BEFORE THE UNITED STATES  
NUCLEAR REGULATORY COMMISSION

DOCKET NO. 50-286

AMENDMENT NO. 2 to  
APPLICATION FOR AMENDMENT TO  
OPERATING LICENSE

RESPONSES TO NOVEMBER 20, 1977 QUESTIONS BY NRC

FIGURE 2.1.5

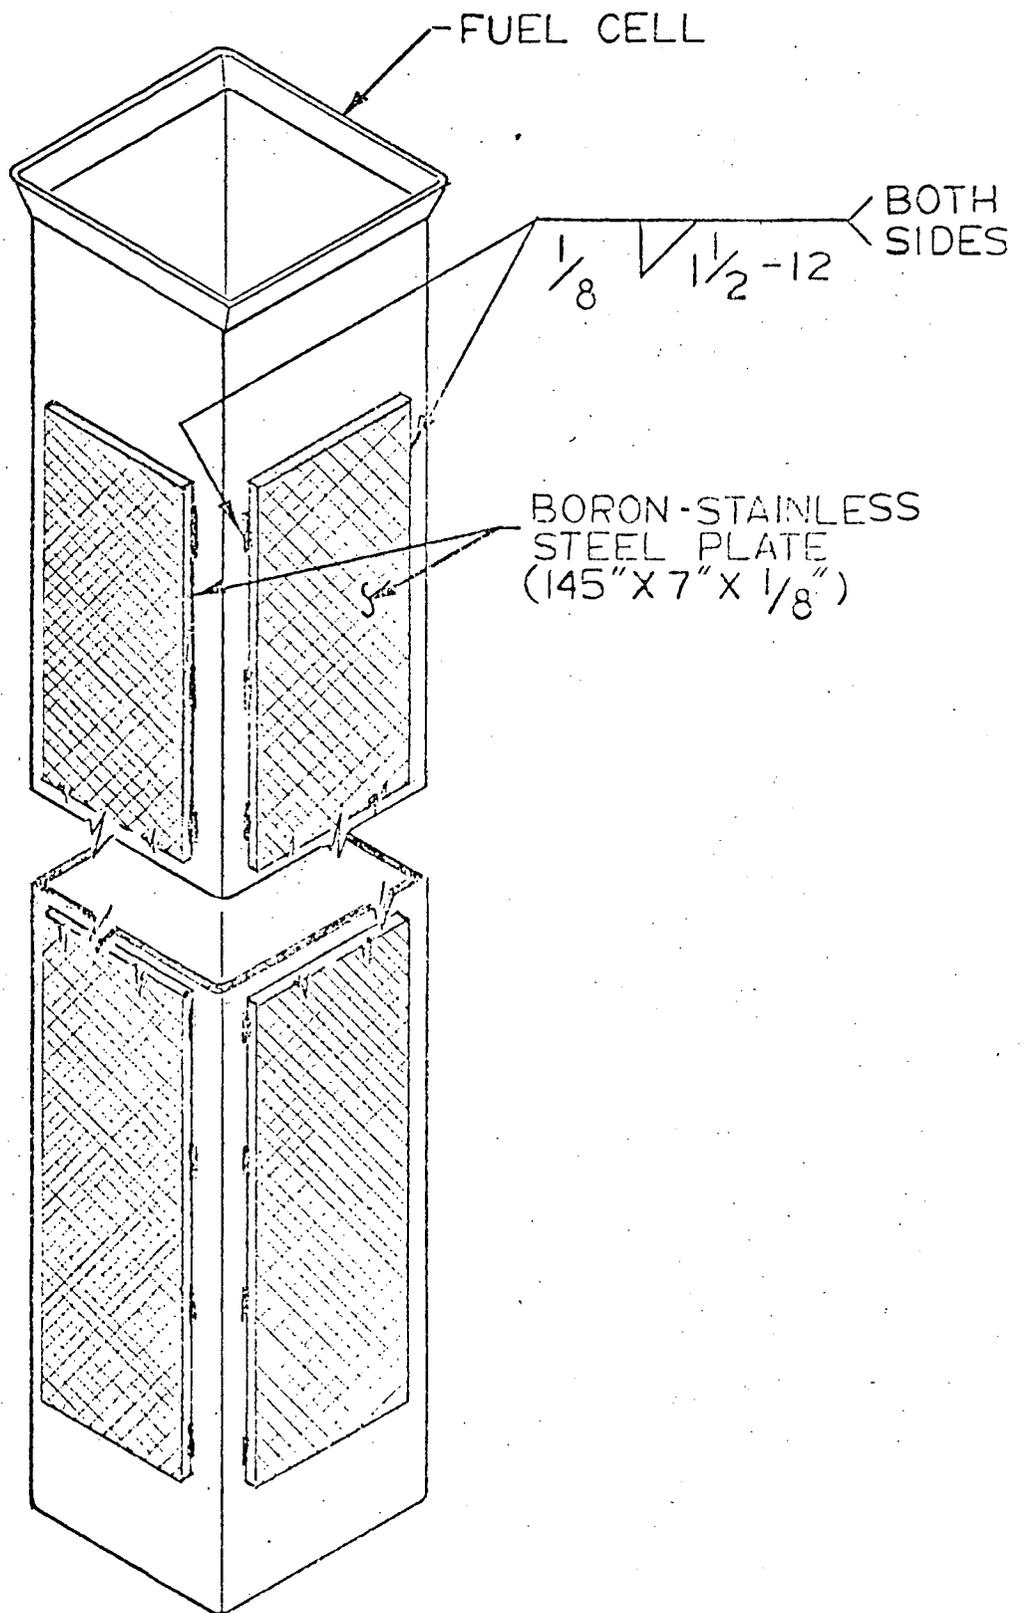
2. Describe and provide clear drawings of the locations and type of welds used to attach the boron-stainless steel plates to the sides of the fuel storage cells. Describe the procedures and qualifications used in performing these welds and discuss the effects of welding on the material properties requested in number 1.

The weld used to attach the boron-stainless steel plates to the sides of the fuel storage cells is a 1/8 inch fillet weld as shown on Figure 2.1.5. This is a skip weld, 1-1/2 inches on 12 inch centers.

The weld procedure, which will be used for this weld, will utilize the gas metal arc welding process (GMAW-S). This weld process was selected to minimize the heat input during welding in order to reduce the formation of a boron phase in the weld heat affected zone. ER-312 filler metal will be employed to ensure a high ferrite content in the weld metal and therefore, reduce the possibility of microfissuring caused by large or connecting boron phases. The weld procedure will be qualified as a fillet weld test of the production joint. The qualification will be run at the maximum and minimum heat inputs allowed by the procedure, and in the most restrictive joint position expected during production welding. The qualification will be in compliance with Regulatory Guide 1.71.

Preliminary testing has been performed on the production weld joint using the above described weld procedure. This testing involved ultimate tensile tests of the production weld joint (i.e., a fillet weld shear test which results in almost pure tension on the fusion surface of the boron-stainless steel). The ultimate tensile strength ranged from 36 to 51 ksi. All the test specimens failed at the fusion zone surface of the boron-stainless steel. Based on the allowable stress limits for ASME Section III, Subsection NF for linear component support welds, an allowable shear stress on a fillet weld (regardless of the direction of application of the load) can be derived by taking three tenths (0.3) of the ultimate strength. Using the minimum value of the ultimate strength range, the allowable fillet weld shear stress would be 10 ksi. No elongation data was accumulated during the testing.

FIGURE 2.1.6 Rack Interties

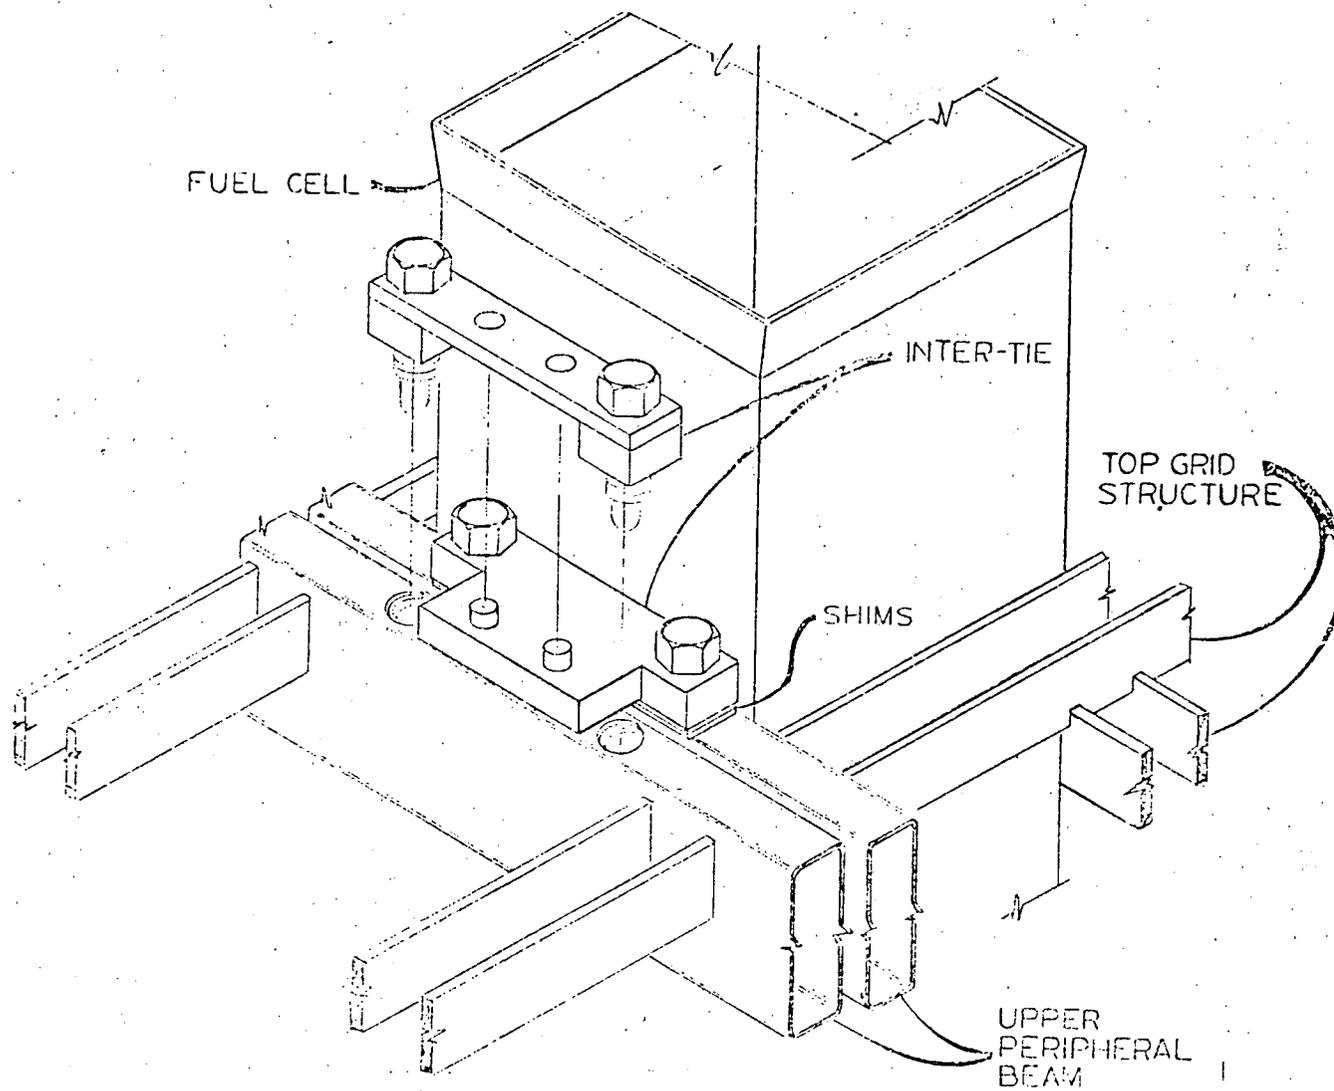
6. Describe the extent to which interaction between storage racks was analyzed including a clear description of the rack to rack interties and the boundary condition used to model the interties.

Details of the rack intertie design are shown in Figure 2.1.6. Three (3) such interties are provided at all rack-to-rack interfaces. The interties are designed to permit relative horizontal movement between racks to accommodate thermal expansion. Rack overturning under seismic conditions is prevented by transmission of vertical shear forces from rack-to-rack. The minimum requirement for seismic stability is two (2) racks, intertied at their common boundary. This condition occurs in the North-South direction at Racks B-4 and B-5 shown on Figure 2.0.2 Revision 1, attached. This is the configuration which was modeled in the seismic analysis. Figure 2.1.1 (Revision 1) shows the boundary conditions applied to the seismic model at the rack interties.

FIGURE 2.1.7 Rack Base and Embedment Details

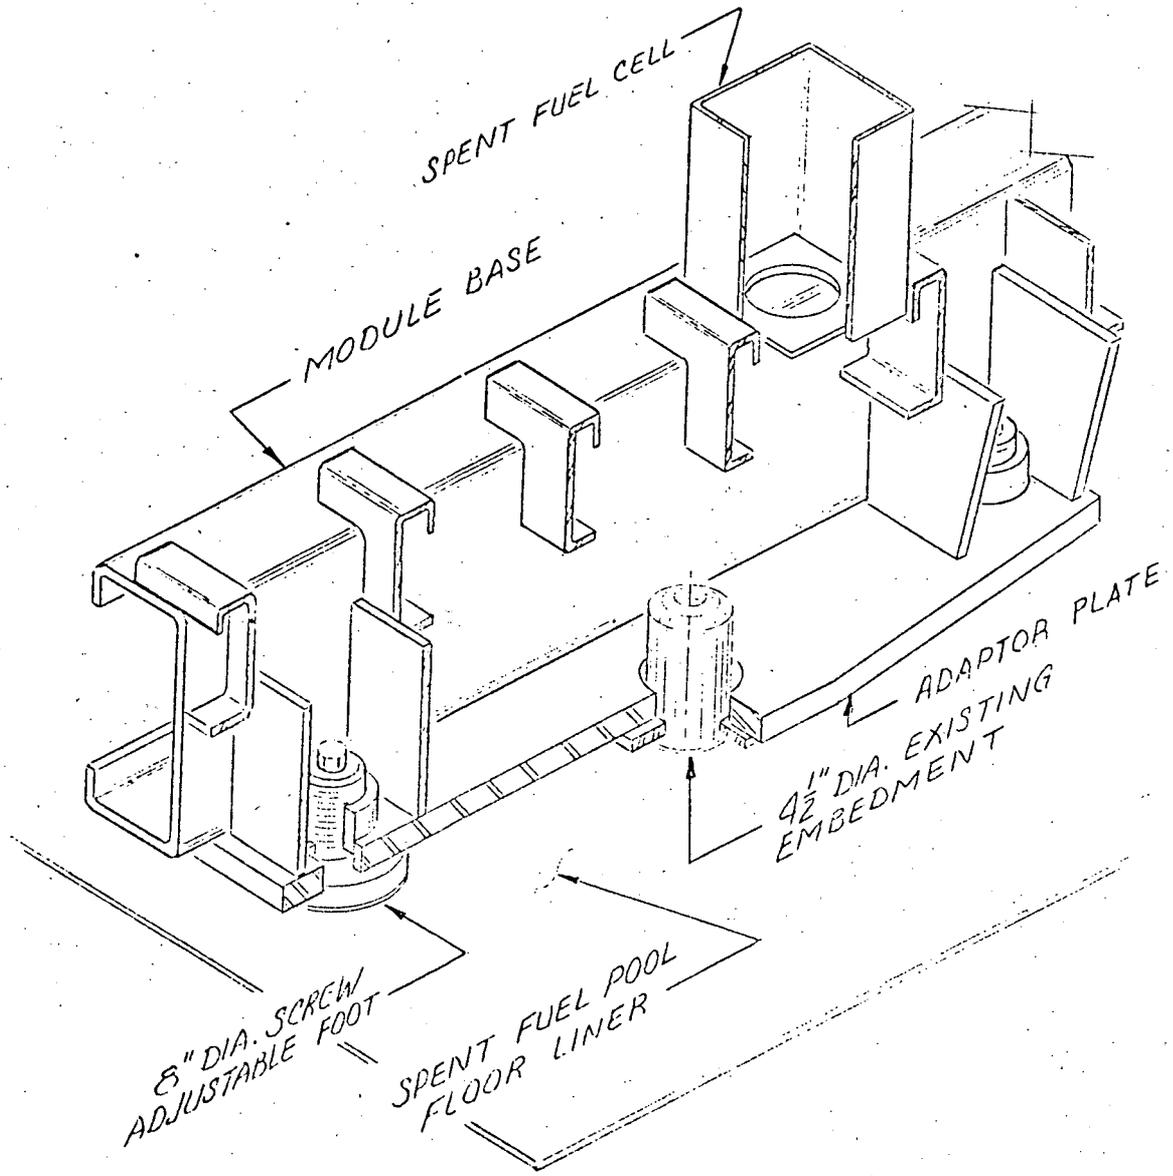
8. Provide clearer sketches of the rack feet and pool floor embedments which in combination with friction are relied upon to resist horizontal seismic loads. Discuss the possibility and effects of sliding of racks on the pool floor.

Details of the screw adjustable rack feet and attachment of the racks to the existing embedments are shown in Figure 2.1.7. The existing embedments consist of lengths of 4" (4.5" O.D.), schedule 40 pipe welded to the pool floor liner plate. The allowable shear loads on each embedment are 29,100 lbs and 46,600 lbs for OBE and SSE loadings respectively.

Loads are transmitted from the rack structure to the embedments by adaptor plates welded to the bases of the racks. Horizontal seismic loads are resisted by the existing embedments and frictional forces on the rack feet working in combination.

At the maximum allowable load on the existing embedments, the minimum friction coefficients, required to resist the horizontal seismic loads, are 0.23 and 0.29 for OBE and SSE loadings, respectively. The reference\* provides details of a variety of friction tests representative of water reactor operating conditions. For a Type 304 stainless steel sliding couple, the following friction coefficients were measured.

The actual operating condition is at approximately 120°F and an average bearing pressure of 440 psi at which conditions a sliding coefficient of friction of a least 0.45 would be anticipated. The static friction coefficient would be expected to be even higher. It is concluded, therefore, that there is a margin of at least 50% against sliding of the racks on the pool floor.

FIGURE 2.1.8 Rack A-1 Upper Wall Restraint

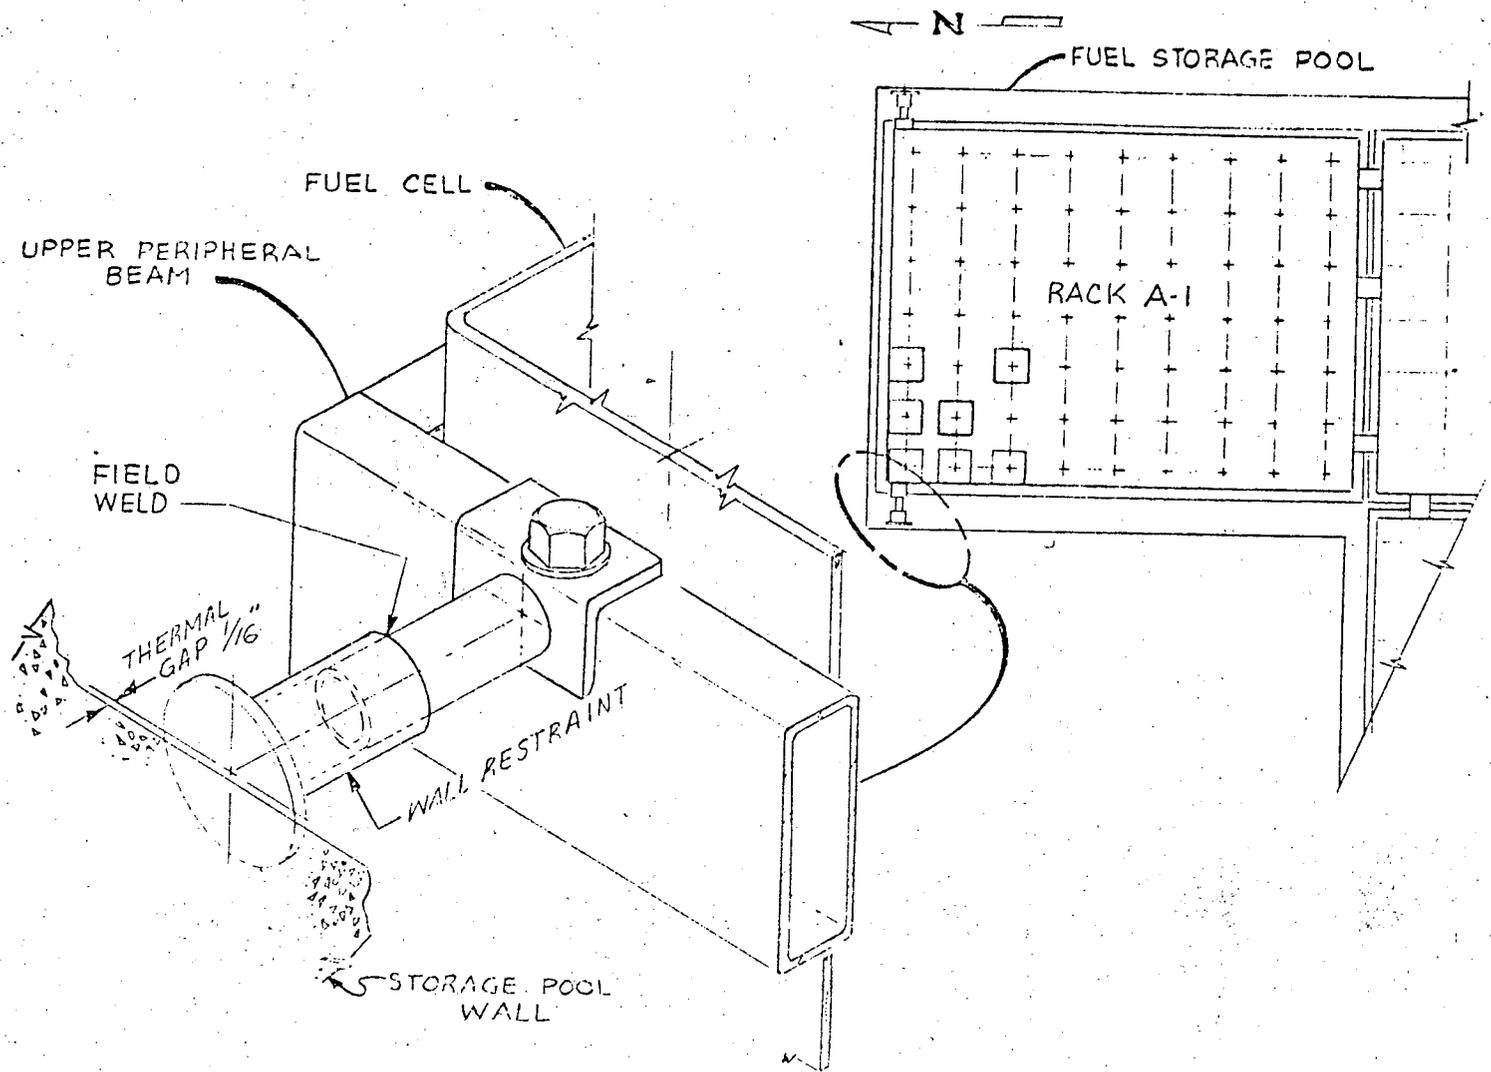
9. Describe the restraints at the top of the racks on the north-east fuel pool wall and any additional gaps between the racks and the fuel pool wall. Discuss the possibility of impacting at these gaps due to possible seismic response, including sliding, and discuss the effects of the impact on the fuel rack and the fuel pool wall.

Details of the upper wall restraints on Rack A-1 in the North-East corner of the pool are shown in Figure 2.1.8. The restraints are bolted to the upper peripheral frame members of the racks and will be adjusted at installation to provide a 1/16" thermal expansion gap. The maximum calculated load on these restraints under SSE loading conditions is 9.85 kips. This load was increased by a factor of 2.0 to 19.7 kips to allow for impact effects resulting from the clearance of approximately 1/32" at normal operating temperature. The maximum allowable load on the restraint and the rack structure is 21.1 kips. The pool wall is capable of resisting a continuous line load of 50.0 kips/ft at the elevation of the restraints. The applied load of 19.7 kips is, therefore, well within the capacity of the pool wall.

FIGURE 2.1.9 Detail At Top Of Fuel Storage Cell

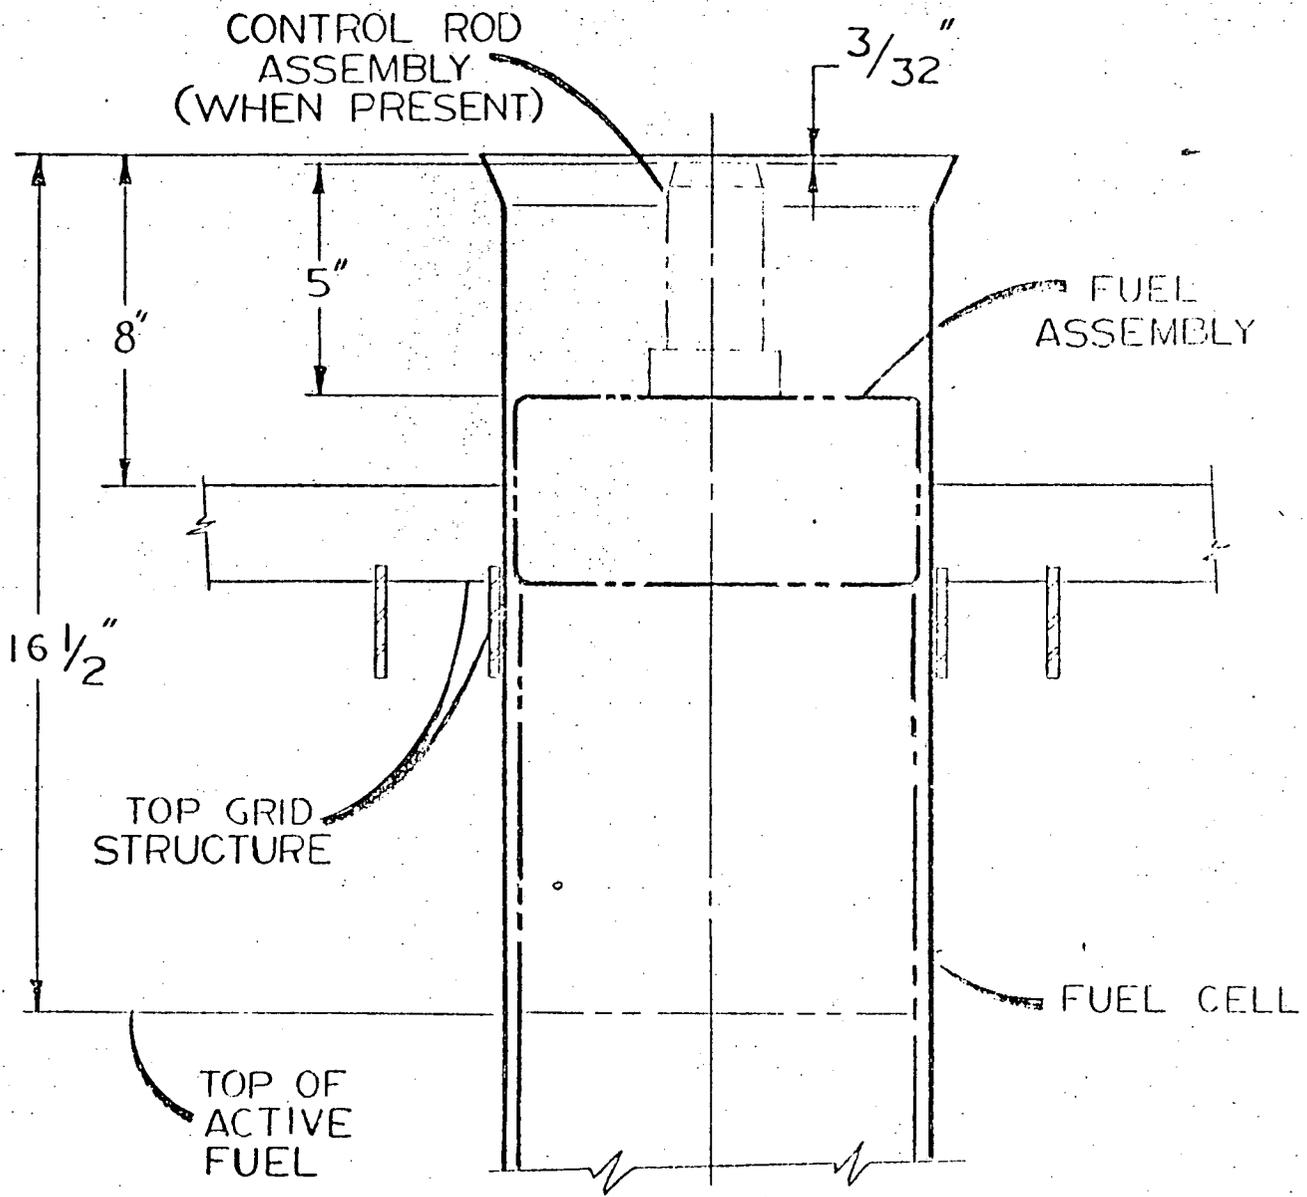
11. In reference to a dropped fuel assembly accident, describe what portion of the fuel storage cell above the stored fuel assembly is relied upon to absorb the energy of a dropped fuel assembly.

Figure 2.1.9 shows the arrangement of the fuel cell with respect to the top grid structure of the rack and a stored fuel assembly. The 8" of fuel cell protruding above the top grid is relied upon to absorb the energy of a dropped fuel assembly. The impact is primarily absorbed by local crushing of the top 2 to 3 inches of the cell, above the stored fuel. The maximum deflection of the top of the cell is approximately one (1) inch.
